# Manual Update Sheet

Document Being Updated: *TMS320C6000 Peripherals Reference Guide*

Literature Number Being Updated: SPRU190D

This Manual Update Sheet (SPRZ122C) describes changes for the *TMS320C6000 Peripherals Reference Guide* (SPRU190D).

Figure 10-51. TMS320C64x Standard Synchronous FIFO Read for CE0, CE1, or CE2

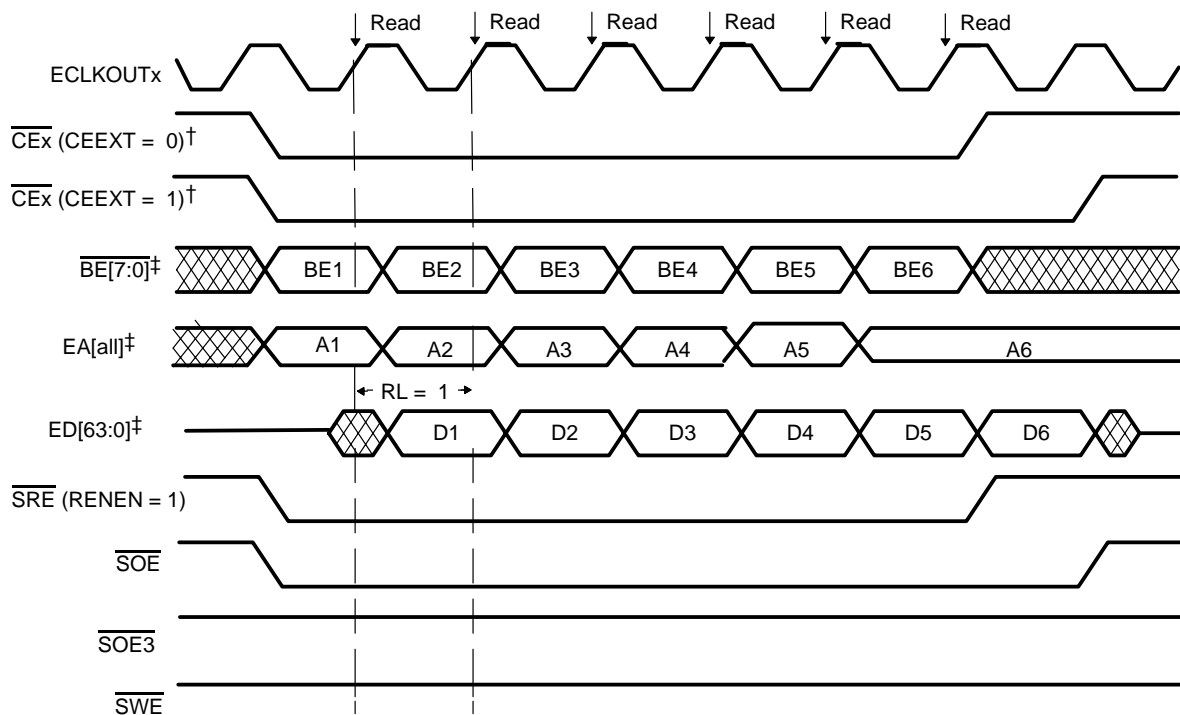
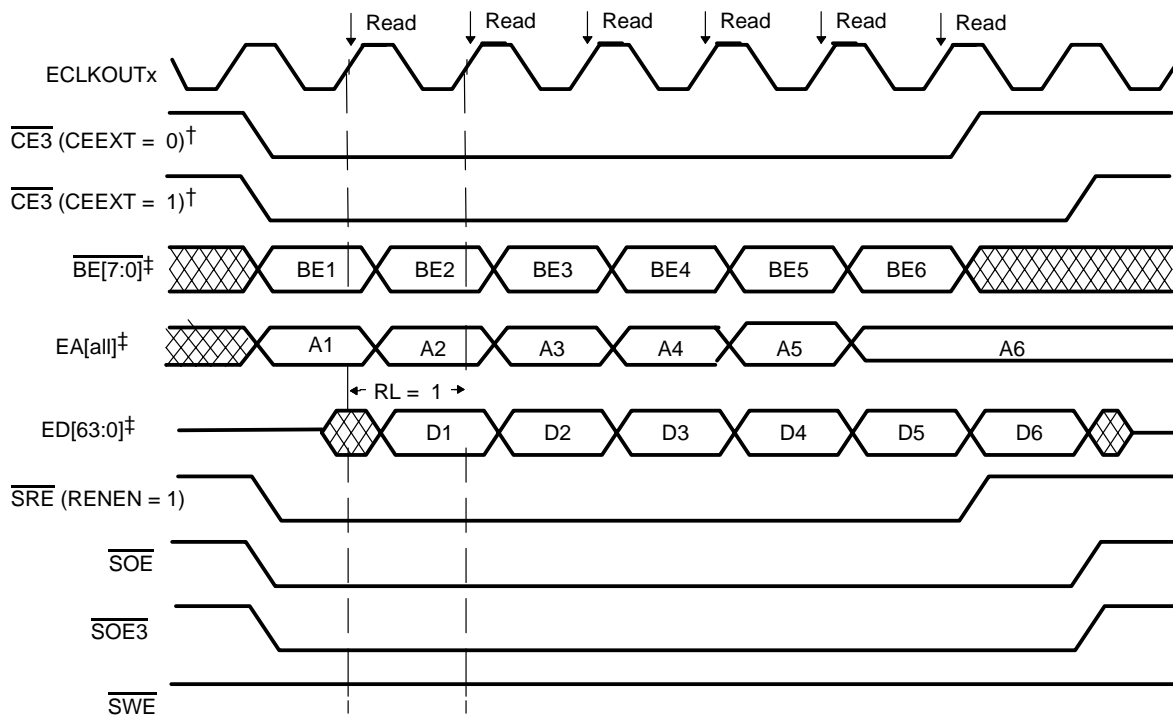
10-88 Change Figure 10-51 into two figures. The subsequent figures are renumbered accordingly:

Figure 10-53. TMS320C64x FWFT Synchronous FIFO Read

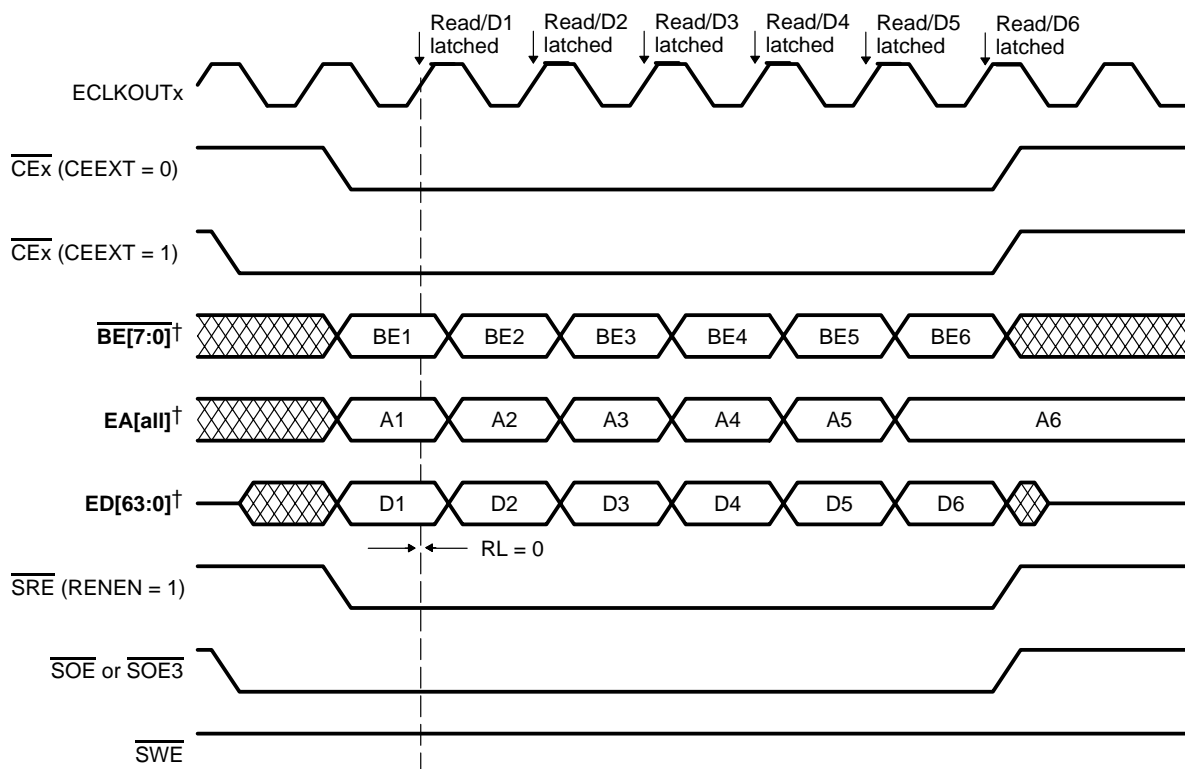
10-90 Change the signal names and footnote in Figure 10-53:

† Figure shows 64-bit interface. The MTYPE field selects the interface type to be 8-, 16-, 32-, or 64-bits wide.  
 For 32-bit interface,  $\overline{BE}[3:0]$ , EA[all], and ED[31:0] are used  
 For 16-bit interface,  $\overline{BE}[1:0]$ , EA[all], and ED[15:0] are used

*Figure 10–63. TMS320C64x Ready Operation*

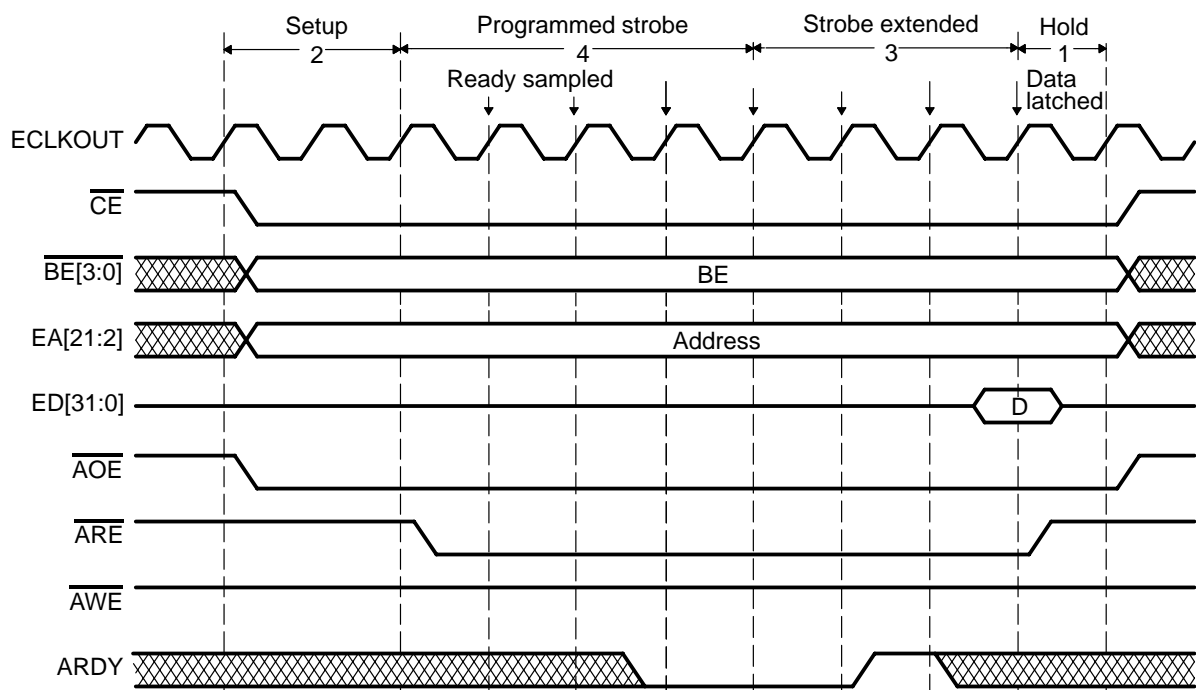
10–102            Add a new Figure 10–63. The subsequent figures are renumbered accordingly:

Figure 10-65. EMIF Clock Block Diagram—TMS320C64x EMIF

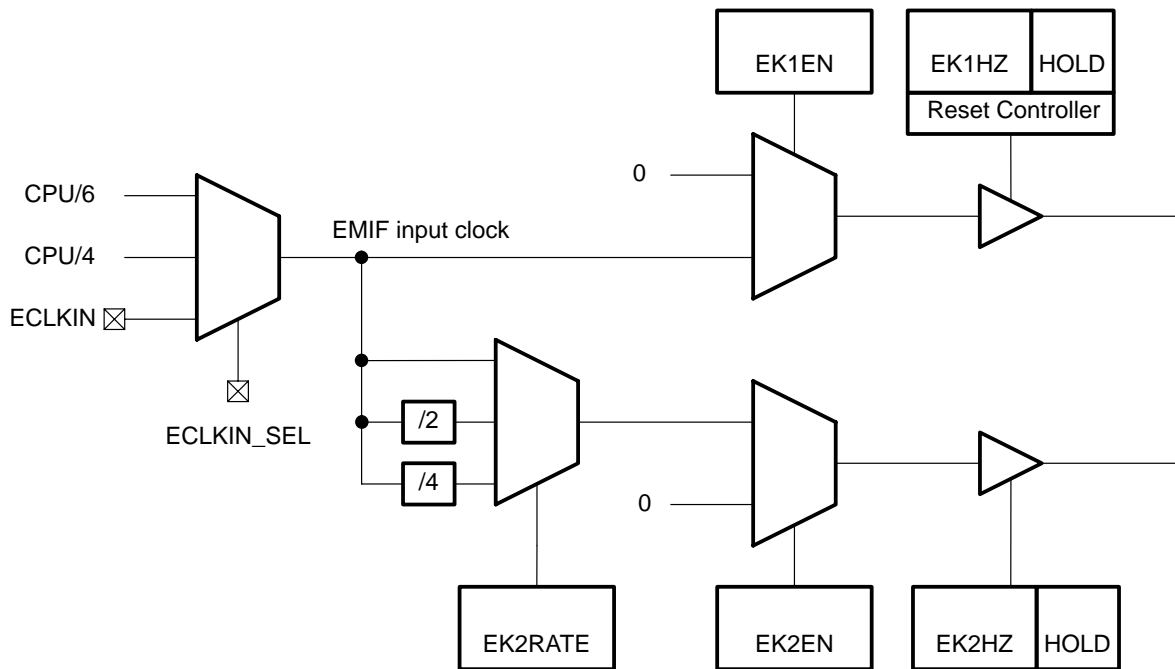
10-113 Add new Figure 10-65:

Figure 13-6. *Timer Operation in Clock Mode ( $C/\bar{P} = 1$ )*

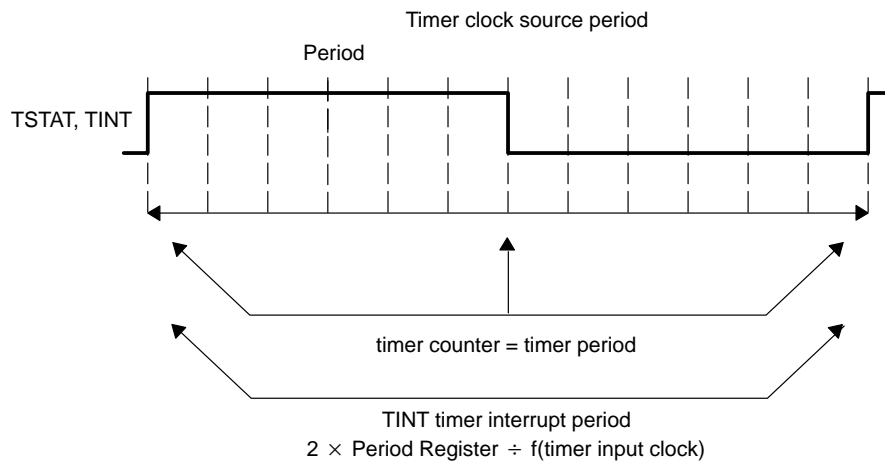
13-9 Change Figure 13-6:

*Figure 17–11. GPIO Interrupt Polarity Register (GPPOL)†*

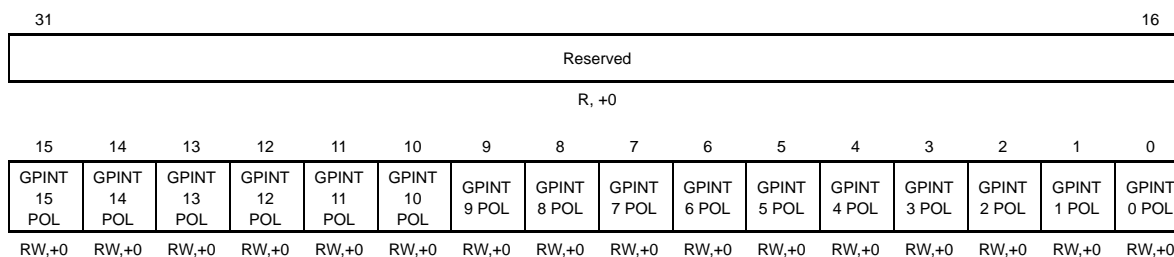
17–11            Change Figure 17–11. Add a footnote.

† For GPINT mapping with EDMA events and external interrupts, refer to device-specific datasheet.

*Figure 18–3. UTOPIA Control Register (UCR)*

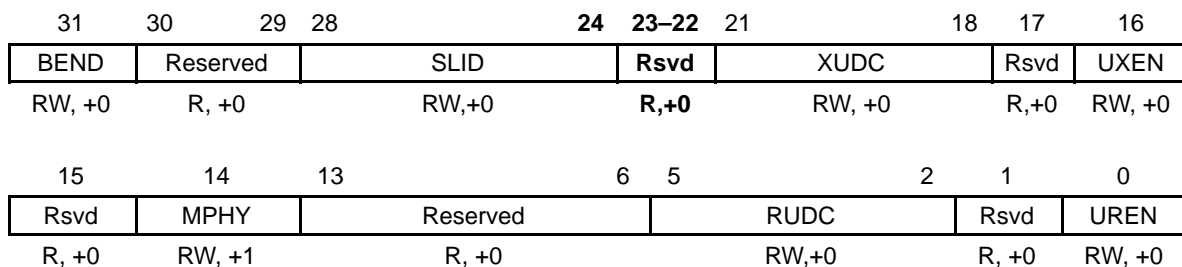
18–5            Change the SLID bit range in Figure 18–3:

*Figure 18-7. ATM Controller Slave Transmit Timing*

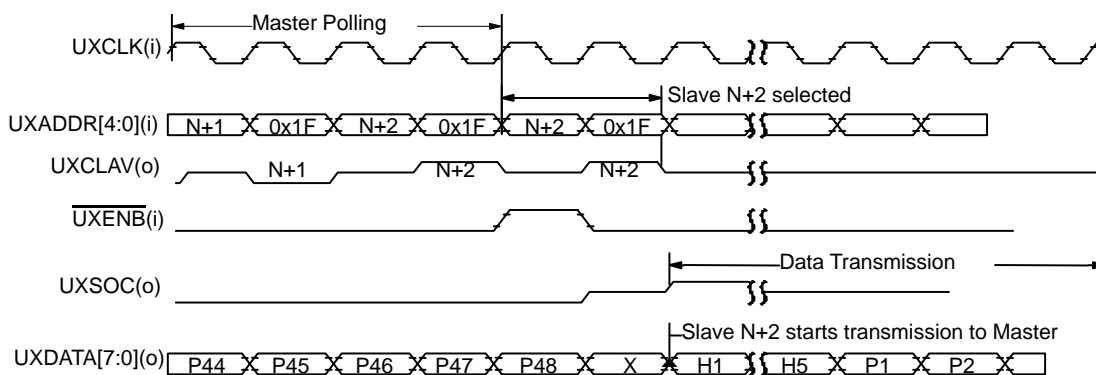
18-11              Change the UXCLK signal in Figure 18-7:

Figure 18-8. ATM Controller Slave Receive Timing

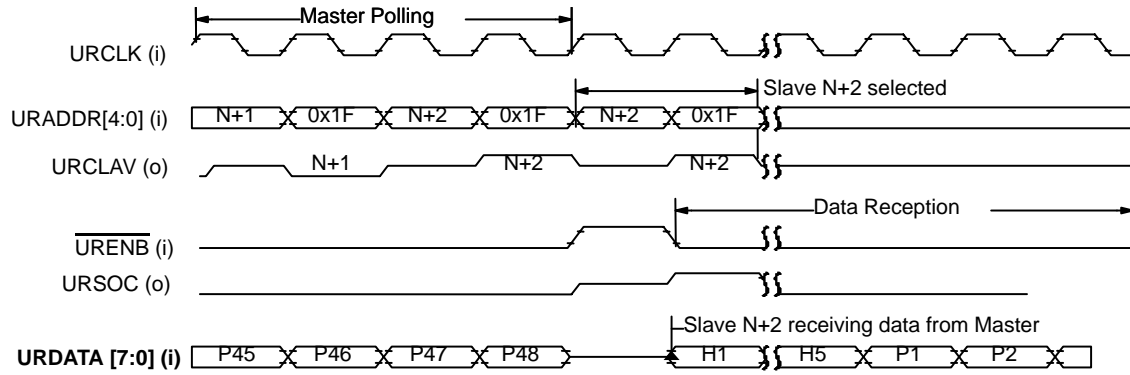
18-14 Change the URDATA signal name in Figure 18-8:
